TSB # 323-0053
Prince Castle
355 East Kehoe Blvd
Carol Stream, IL 60188
Date 10/30/2017

In a going effort to ensure quality on our Genuine OEM Equipment we are Issuing a Technical Service Bulletin for our DCFT Toaster Series. This TSB depicts how to correct reverse compression issues. Please Read Detailed information below.

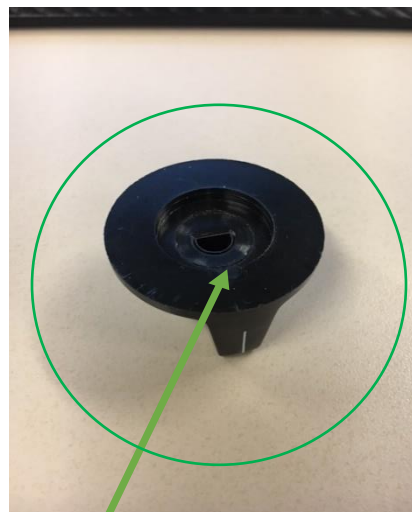
Compression settings are opposite of the original OEM setting due to the knob indicator mark and D slot being reversed. Early Generation Knobs (OEM Part # 526-221) are not affected.

Old OEM Knob Part # 526-756

Locator flats 180 deg. across to each other

New OEM Knob Part # 526-757
